# febi 39245

Repl. No. 06H 145 710 D

## Diverter Valve

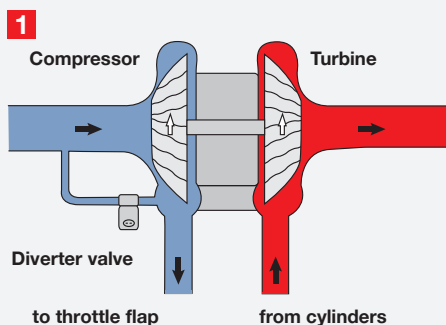
The old version of the valve has a rubber diaphragm which can be the reason why the unit fails (see Fig. 2). The full charging pressure is no longer built up as air is pumped in a circuit even with the throttle flap open.

the valve’s slow switching times also prevent the dynamic pressure downstream of the compressor from reducing which consequently creates the “turbo lag” effect. This not only results in unnecessary slowing down of the turbocharger but also places an enormous load on the closed throttle flap and the turbocharger’s turbine end.

febi recommends replacing the diverter valve with the most up-to-date version (febi 39245). As a piston version (see Fig. 3), the piston ensures that the valve functions perfectly.
